SUBJECT: COMANCHE PEAK STEAM ELECTRIC STATION (CPSES)
DOCKET NOS. 50-445 AND 50-446
ADVANCE FSAR SUBMITTAL - COOLING POND HYDROTHERMAL ANALYSIS

The attachment to this letter provides an advance CPSES FSAR submittal to facilitate NRC Staff review of the subject area in support of licensing Unit 2. The attachment is organized as follows:

CPSES - FINAL SAFETY ANALYSIS REPORT (FSAR)
AMENDMENT / REVISION 87
DETAILED DESCRIPTION

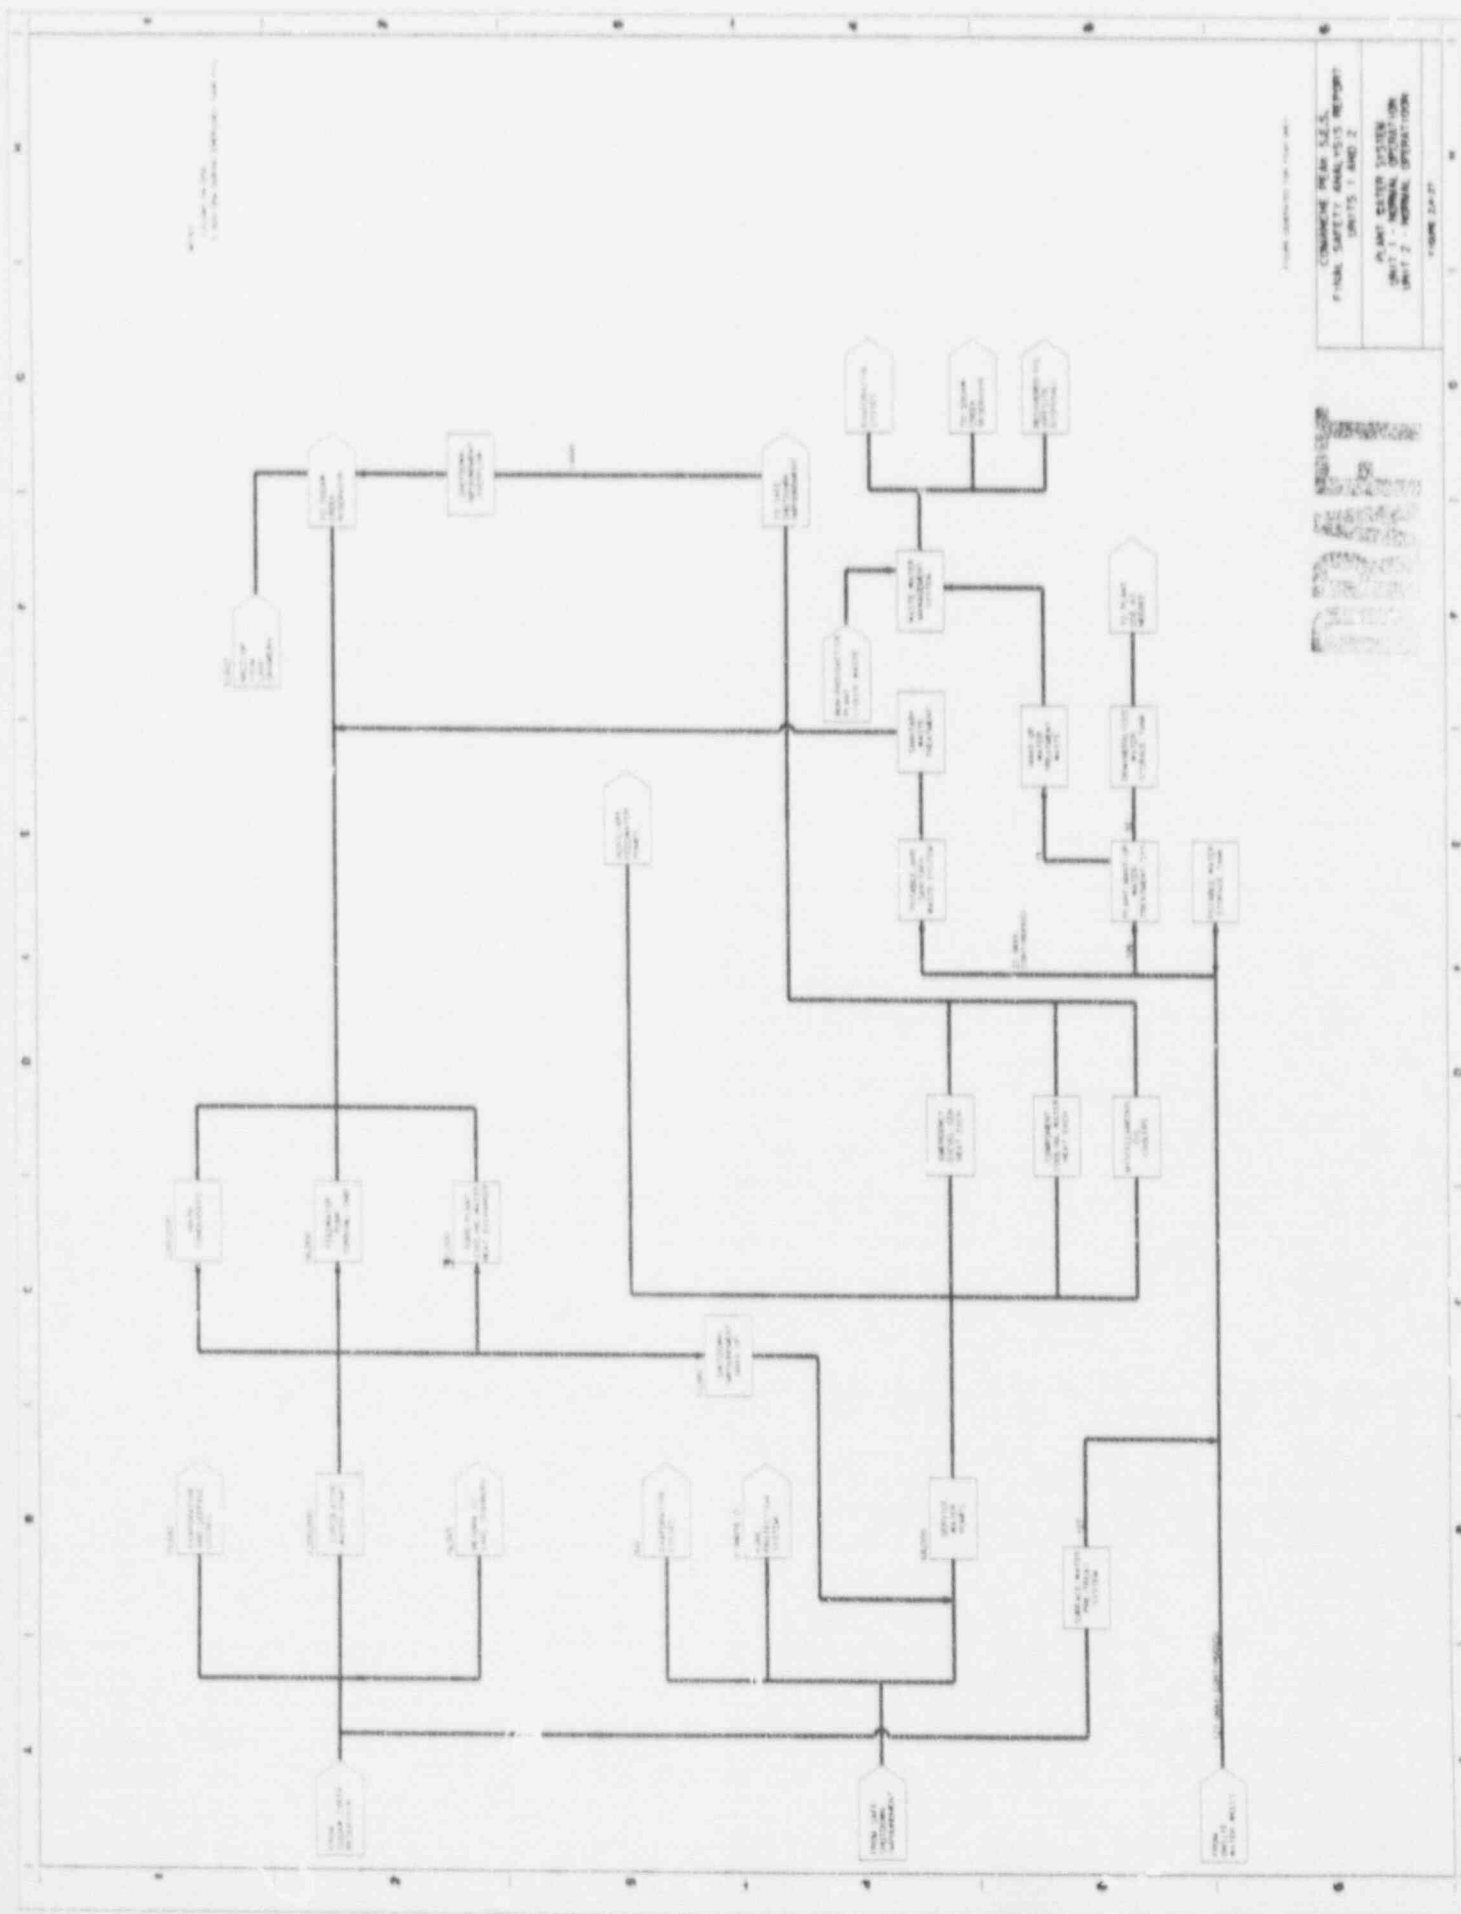
- Figure 2.4-26,27 3 See sheet no(s): 28 and 29
Corrects the evaporative losses for the SSI during
various plant conditions.
Addition :
Evaporative losses of 16,365 gpm, as previously
indicated are not correct. The evaporative losses are
calculated for the plant conditions and are revised
in the figures.
Change Request Number : SA-92-720.13
Commitment Register Number :
Related SER : 2.4 SSER :
SER/SSER Impact : No

Figures 2.4-26 through 2.4-29 describe cooling water requirements for the various modes of plant operation. Section 9.2.5 discusses design bases and safety functions of the SSI as the CPSES ultimate heat sink.
